AMENDED RESPONSE PLAN FOR COLISEUM BOULEVARD PLUME

**Submitted to:
The Alabama Department of Environmental
Management**

January 5, 2001

8 FOOT CHAIN LINK INDUSTRIAL FENCE WITH TENSION WIRE

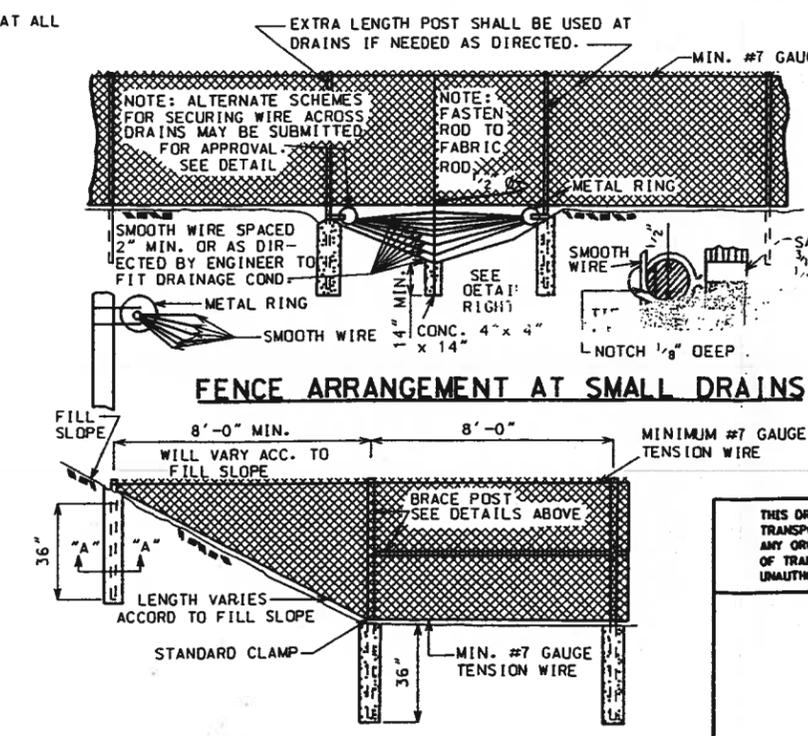
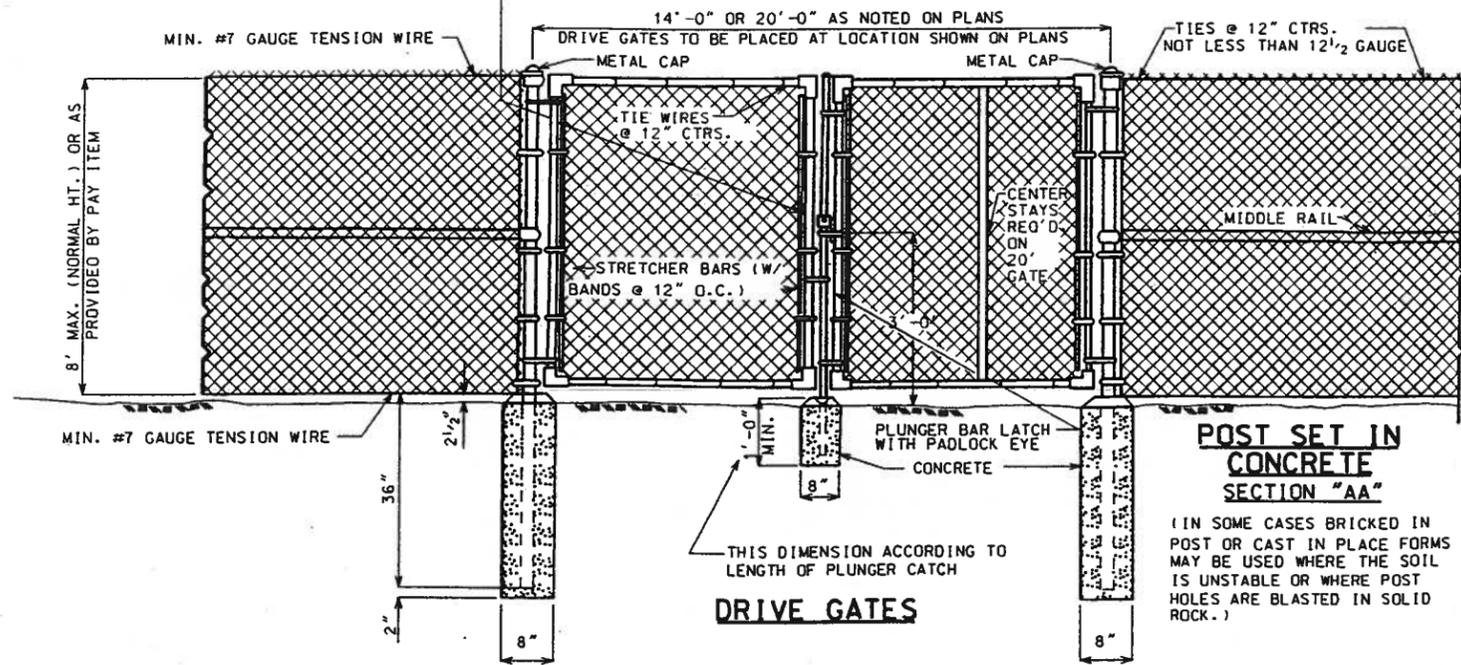
ALDOT has modified the fence design based on all the comments submitted to the design of the fence itself. Included with this plan is the new fence drawing which illustrates the new design, which simply is the erection of an eight-foot chain link fence, with tension wire for structural integrity. Also included is the layout of the temporary fence. ALDOT will monitor the
